Access Compliance Report

Public Rights-of-Way

(Curb Ramps)

Intersection ID: 53095	Main Street: ALEXANDER_DOWD_DR	Cross Street: DEERFIELD_MANOR_DR	Location: S
ADA ID: C49368E730D1	Ramp Type: Perp	Initial Pass/Fail: Pass	Overall Compliance: No
Severity Score: 5			
Codes/Mitigation Info/Possible Solution		Field Measurements/Component Compliance

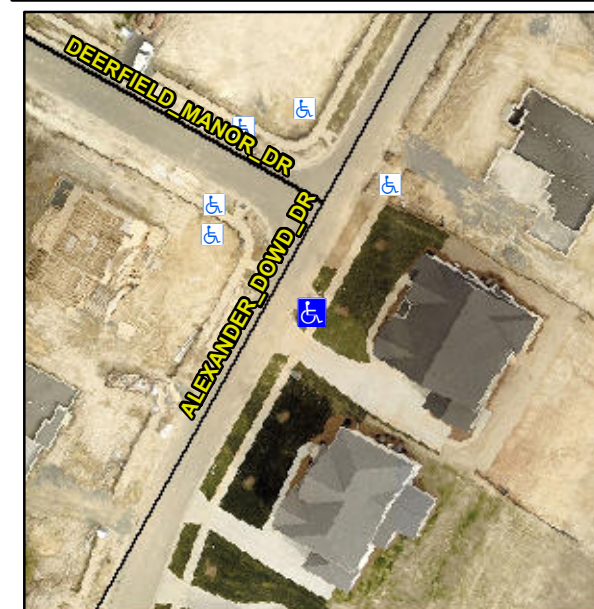
Remove & Replace Detectable Warning System. Remove & Replace Gutter.

R305.2, R304.5.4
